Delegated Report		Analysis sheet		Expiry Date:	29/10/2020
		N/A		Consultation Expiry Date:	26/10/2020
Officer			Application Number(s)		
Josh Lawlor			2020/1671/P		
Application Address			Drawing Numbers		
2 Hillfield Road London NW6 1QE			See decision notice		
PO 3/4	Area Team Signature	C&UD	Authorised Officer Signature		
Proposal(s)					
Erection of two storey roof extension with front and rear dormer windows, erection of four storey rear extensions from basement level with roof terraces to ground, 1 st , 2 nd , and 3 rd floor, following partial demolition of existing rear elevation and rear pitched roof, excavation for enlarged double basement including creation of 2 front lightwells, and associated alterations and cycle parking in front forecourt, all in association with the conversion of 2 dwellinghouses to 9 self-contained flats (Class C3).					
Recommendation(s):		Refuse Planning Permission

Application Type:		Full Planning Permission

Figure 2: 3D views of existing (left) and proposed (right) rear

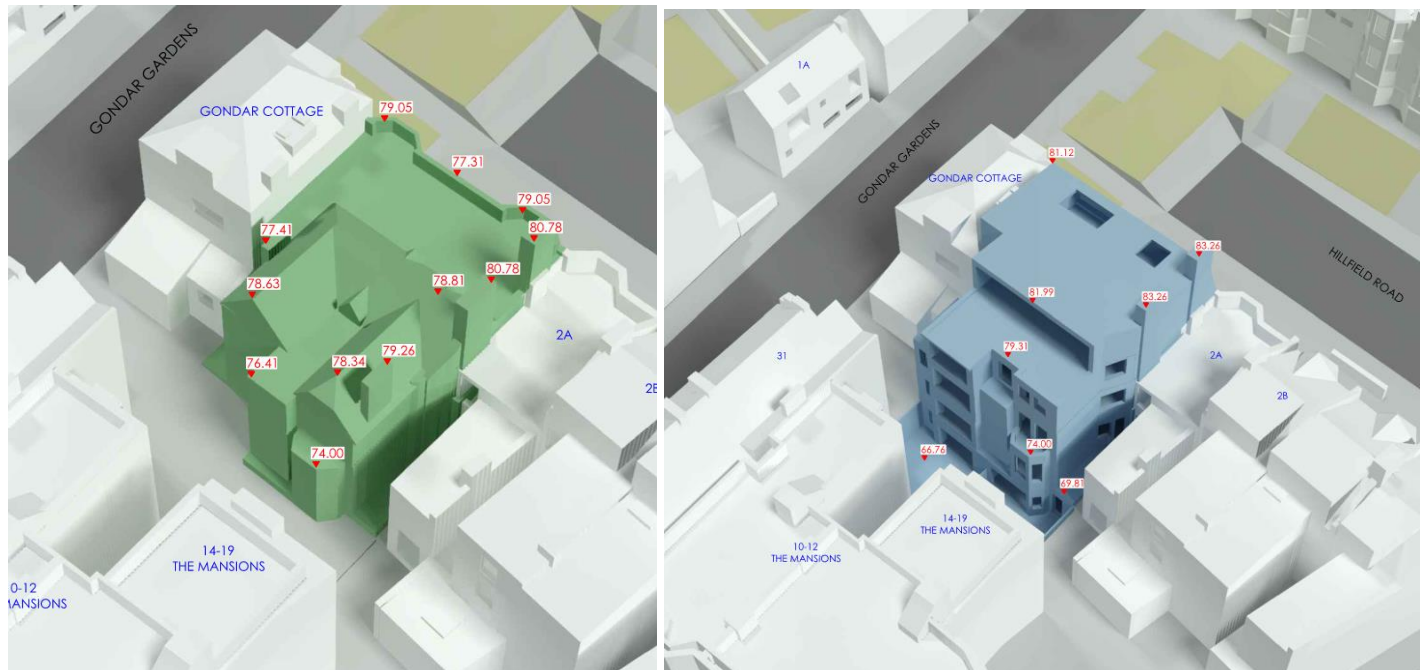
- 1.6. The applicant has not provided a demolition plan for the rear elevation to indicate what parts of the rear would be demolished. However the 3D views shown in figure 2 indicate that, together with the pitched roof, almost the entire rear elevation would be demolished. It appears only the ground floor bay and two storey projection (from ground) would be retained, shown in figure 1 below.

Figure 4: Proposed section AA of double basement floor to ceiling height

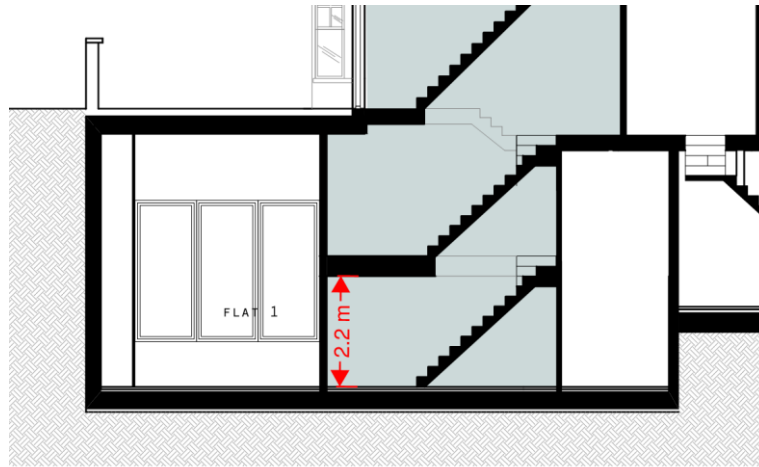
- 4.6. The proposed section A-A indicates that the lower floor (ie. bottom basement level) Flats 1 and 2 would have a floor to ceiling height of 2.2m. This would fail to comply with the minimum 2.3m requirements as per the Government space standards.

- 4.23. The future occupants of the basement Flats 1 and 2 would have a very poor quality of outlook as the each living room and bedroom would only have views into a front lightwell which is two storeys below ground level. Their sole view would be enclosed by a solid wall over 5m high and 3m away. There would be no windows to provide natural cross-ventilation. It is expected that cooking fumes from the kitchens located away from the front lightwells would not have proper airing without mechanical ventilation. The outlook and ventilation for the basement 1 bed units is considered to be unacceptable.

Figure 7: Proposed section AA and front elevation

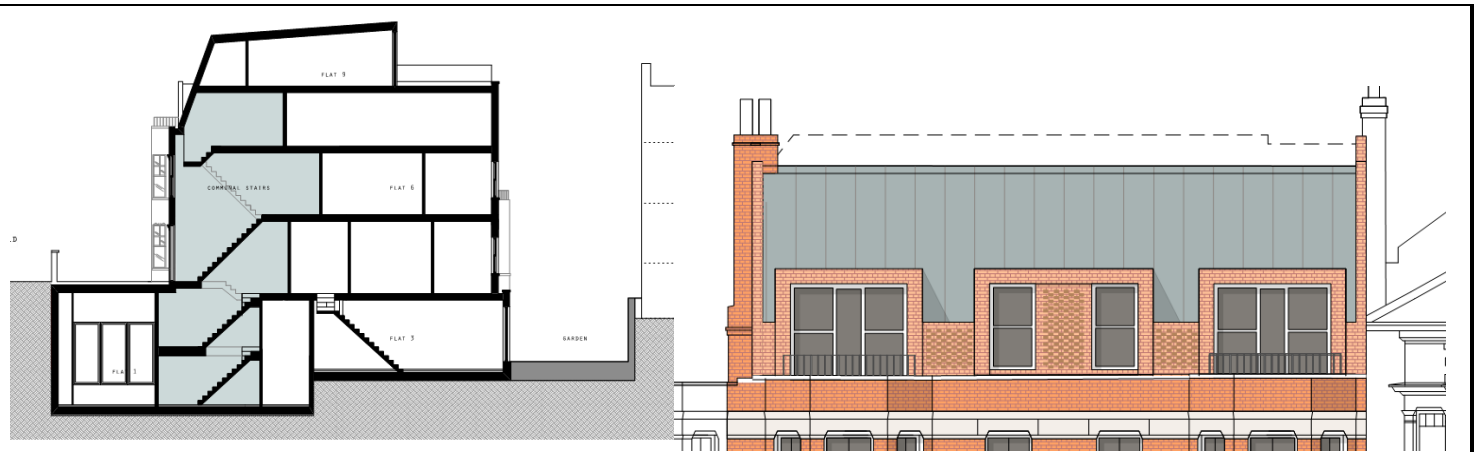
- 6.4. Roof alterations must be architecturally sympathetic to the age and character of the building and retain the overall integrity of the roof form. The proposed two storey roof extension would make a complete break from the established style of single storey pitched roofs on the street. There would be a second floor extension with red brick vertical walls with a 3rd floor mansard style extension above. The two storey extension would have the appearance of a double height flat-topped mansard roof extension. The extensions would add excessive bulk and mass to the host building which would overwhelm the elevation. The three sets of brick-faced dormer windows are excessively scaled. The size of the glazing does not reduce in size going up the building (hierarchy of windows) thus overwhelming the elevation. The two dormers over the existing bays would feature timber framed doors to enable the use of the 2nd floor bay roof as terraces with balustrading provided. These terraces would add further visual clutter which contributes to the overwhelming appearance of the extensions. The extensions would be visible in local views and would appear at odds with the domestic late victorian architecture.

- 6.5. The proposed front extensions would raise the roof line considerably above the roof line of adjacent Gondar Gardens Cottage and 2A and 2b Hillfield Rd. The sections in figure 8 show how significantly the extension's gable ends would rise over these buildings. These would appear highly incongruous and out of character from street level. The extension would undermine the coherent design of the building and appear visually dominant in the streetscape.

Figure 10: Proposed (left) and existing (right) roof plans

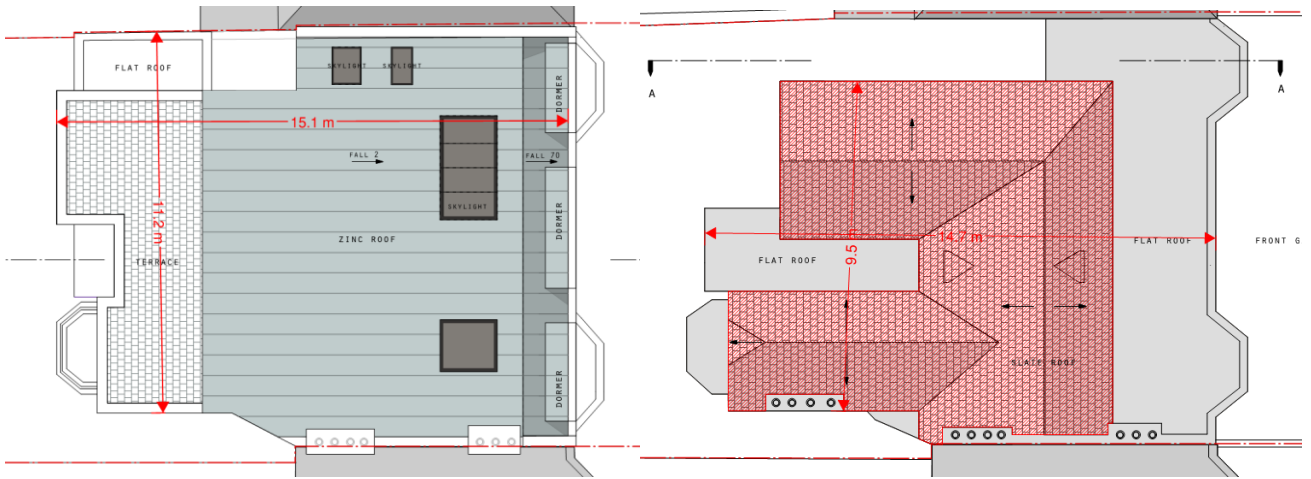
- 6.11. The rear dormer style roof extension contributes to the proposal being insubordinate to the host building. This extension would have excessive amounts of glass and overall mass. The scale and proportions of the building would be overwhelmed by the additional extensions which are above eaves level.

Figure 11: Rear massing study

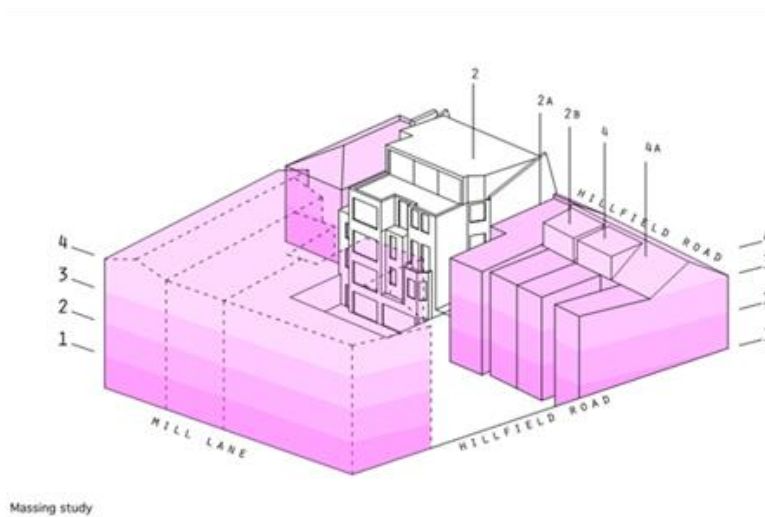
- 6.12. CPG Design (2019) states that extensions should respect and preserve the historic pattern and established townscape of the surrounding area. In order for a new extension to be subordinate to the original building, its height and depth should respect the existing common pattern of rear extensions at neighbouring sites. The massing study shown in figure 11 and within the design and access statement suggests that the massing should replicate taller buildings to the rear of the site on Mill Lane. These buildings are higher than those on Hillfield Road. It is an intrinsic feature of the local urban grain of West Hampstead that buildings on the main streets are higher than those in streets behind the main streets. The massing should relate to that on Hillfield Road rather than Mill Lane.

Figure 15: Rear elevation and ground floor plan of Gondar Cottage

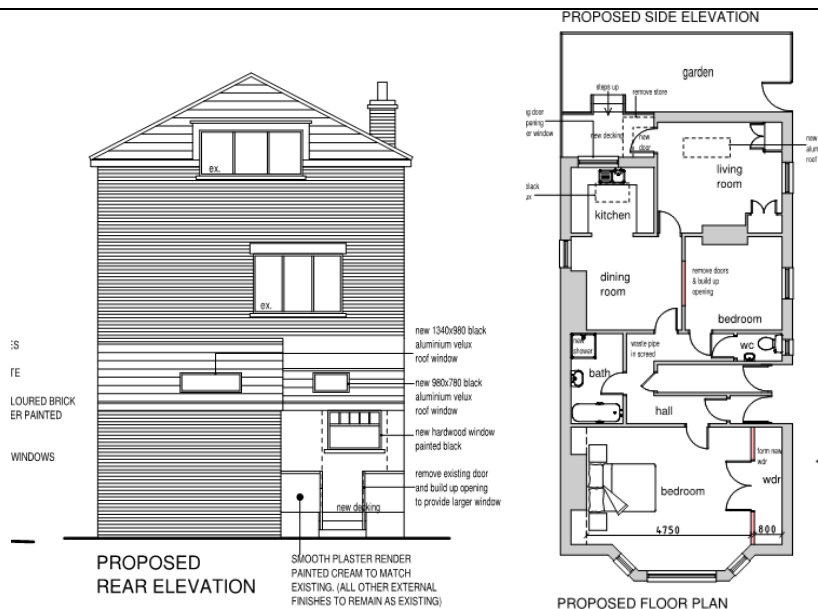
- 7.8. Gondar Cottage
- 7.9. The ground floor test window for Gondar Cottage has an existing VSC of 15.45% which would be reduced to 10.1%, which is a 35% reduction in its former value. The report states that this is a 'test window and it is not known if it exists'. However planning records (ref. 2010/5142/P) indicate that this is an existing window which serves a galley kitchen on the ground floor. This window would experience an appreciable loss of light and is one of two windows serving the kitchen. It is noted that the side window serving the dining room does not appear to have been assessed and is expected to be significantly impacted. However the small galley kitchen is not a habitable room with the same importance as a living room, therefore the impact to this room is not considered harmful to neighbouring residential amenity.

Figure 16: Overlooking distances with neighbouring buildings

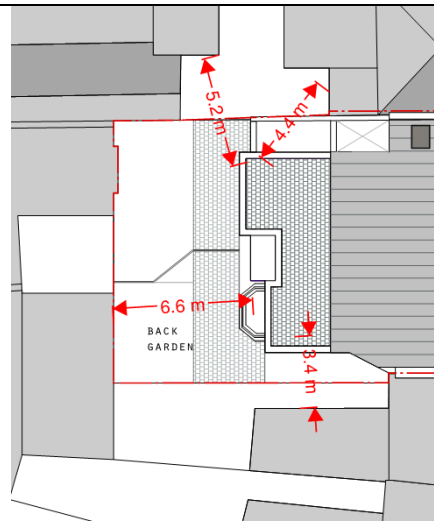
- 7.25. The proposed terraces at rear 1st, 2nd, and 3rd floor would lead to direct overlooking to 2a Hillfield Road, Gondar Cottage, Flats with rear windows at Gondar Mansions and flats with rear facing windows on Mill Lane. Figure 17 shows that the edge of the roof terraces would be within 6m of neighbouring windows. Indeed users of the terraces would have direct views into neighbouring windows which is unacceptable. To overcome this overlooking it would be necessary to install 1.8m privacy screens across all the rear terraces. However this would add unwanted visual clutter and bulk to the building and cannot be supported in design terms. The proposed terrace would create opportunities for overlooking of multiple neighbouring habitable rooms at close distances which is considered unacceptable. It is noted that some acute angled views may not lead to direct overlooking of windows. It is also noted that there are existing side facing windows associated with the existing rear outrigger which would be replaced on more or less a like-for-like basis.

Figure 17: 2007 approval (left) and current scheme (right)

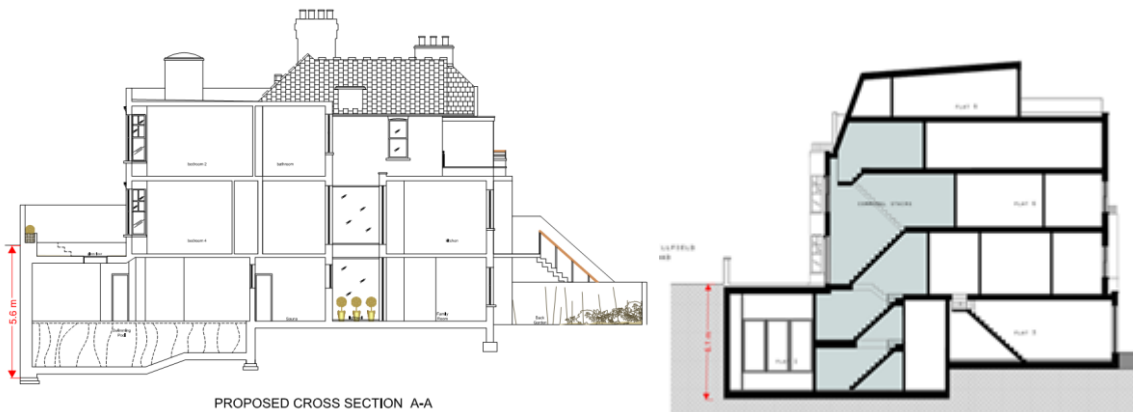
- 8.4. The plans indicate greater basement level excavation than was approved in 2007. The depth of the basement would be increased by 500mm across an approximate 12m depth of the site, measured from the front boundary. The proposal constitutes new development that must be assessed in relation to current local plan policies and guidance. Therefore this application would require a full BIA in accordance with policy A5.

Figure 20: excavated site

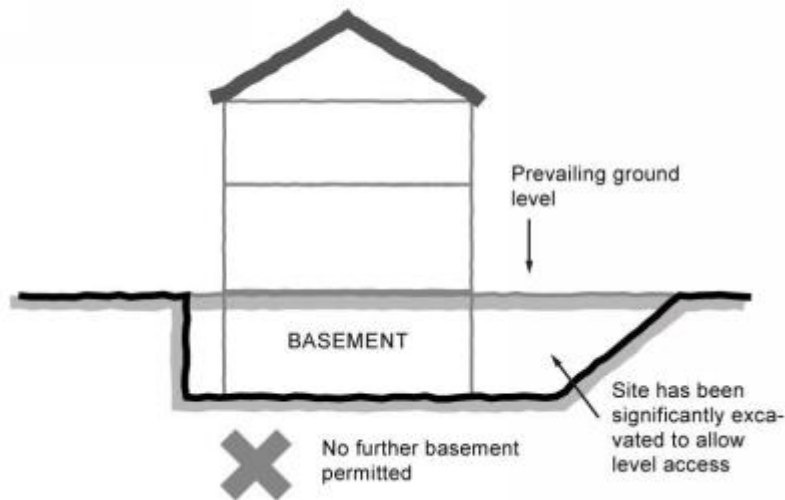
- 8.6. Figure 19 shows that the entire width and length of the site has been excavated. The existing basement extends right up to the rear boundary wall. There is no remaining garden at ground level or vegetation.
- 8.7. The proposed excavation would be below the existing basement level. The site is an 'excavated site' (see figure 20) and therefore further excavation is not in accordance with policy A5 criterion g.

- 8.8. CPG Basements page 10 table 1 states *'the Council considers a single storey for a basement to be approximately 3 to 4 metres in height. The requirement for storey heights to be no more than 3-4 metres refers to the total depth of excavation. Where appropriate we will allow a proportion of the basement to be deeper to allow development of swimming pools. Allowance of this addition depth will only be appropriate where it does not harm the neighbouring properties or the structural, ground, or water conditions of the area, and where the additional depth is required for a swimming pool and it not being used for any other purposes.'* The proposed basement at the front would be over 5m in height and have two full storeys below ground level. This is contrary to policy A5 criterion f.
